PA/01398/23 (GF/00150/06): AMENDMENTS TO PA 1191/05 INCLUDING: INCREASE IN NUMBER OF APARTMENTS FROM 159 TO 234; RECONFIGURATION OF PARKING LEVELS TO INCREASE NUMBER OF PARKING SPACES FROM 600+ TO 850+; INTRODUCTION OF A GREEN PARKING AREA FOR ALTERNATIVE MODE OF TRANSPORT INCLUDING CYCLING, SCOOTERS, AND TAXIS; REMOVAL OF VEHICULAR ACCESS TO THE CAR PARK FROM HUGHES HALLET STREET LEVEL; INTRODUCTION OF HOTEL (CLASS 3B) TO ALSO SERVE APARTMENTS (CLASS 1); ADDITION OF AMENITIES LEVEL WITHIN DOUBLE HEIGHT LEVEL IN TOWER; CONVERSION OF RECESSED LEVEL OF TOWER HOUSING CORE INTO RECESSED LEVEL; REMOVAL OF THE PAVILION BUILDING; INTRODUCTION OF OFFICE LEVELS WITHIN DOUBLE HEIGHT AREAS IN LOWER BUILDINGS; INTERNAL RECONFIGURATION OF OFFICE SPACES; INTERNAL RECONFIGURATION AND SUBDIVISION OF RETAIL AND FOOD AND BEVERAGE OUTLETS, INCREASING THE TOTAL NUMBER OF CLASS 4B UNITS; CHANGING THE USE OF SOME CLASS 4C OUTLETS TO CLASS 4D AND INCREASING THE NUMBER OF CLASS 4D UNITS, INCLUSION OF EXTERNAL AREAS TO CATER FOR THE USE OF TABLES AND CHAIRS.

LOCATION: TOWNSQUARE, TOWER ROAD, HUGHES HALLET STREET, TIGNE STREET, QUI-SI-SANA LANE, IX-XATT TA' QUI-SI-SANA, SLIEMA.

4. COMMENTS RECEIVED BY ERA

Figure 4 – Plans of the proposed hotel (Source: EIA Coordinator Statement, August 2023, <https://era.org.mt/era-project/pa01191-05/>).

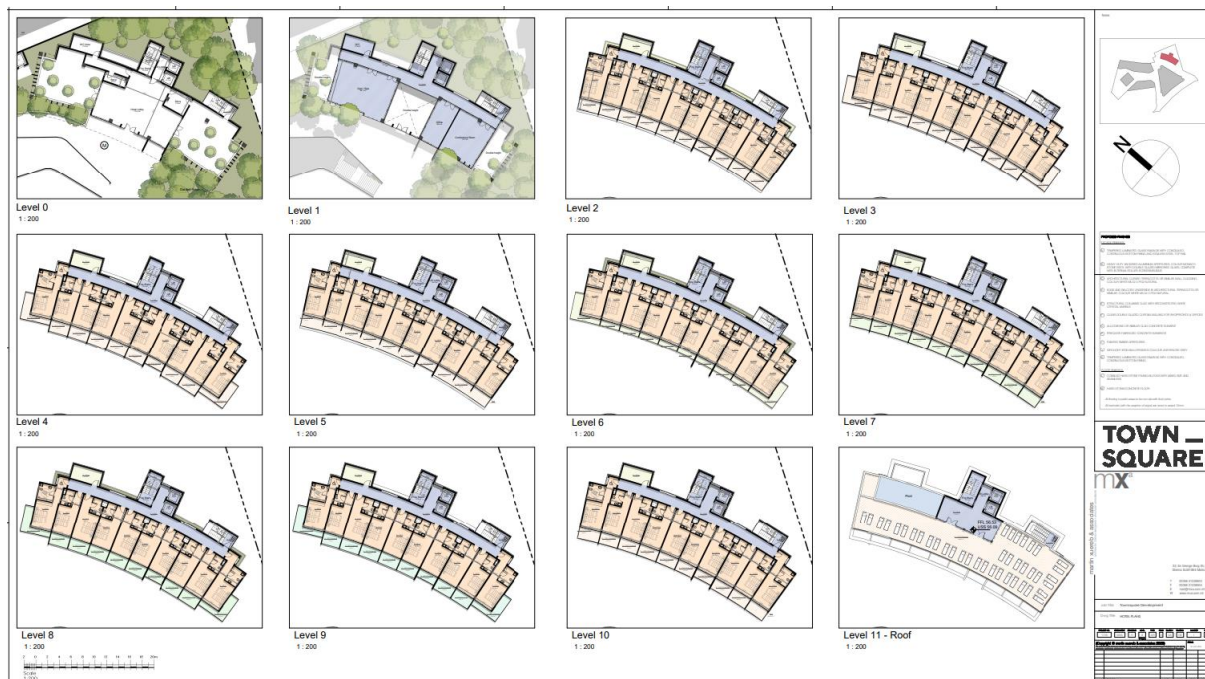
2	<p>The introduction of a hotel in an area previously reserved for an open space with no buildings close to Hughes Hallett street is an extreme revision from the original approved plan and an entire reassessment of the project must be held to ascertain the impact that this will have on environmental quality and logistical bottlenecks, and if so, the modification must be rejected.</p>	<p>Noted. The EIA Addendum considered the additional impact on air quality of the traffic generated from the hotel.</p>
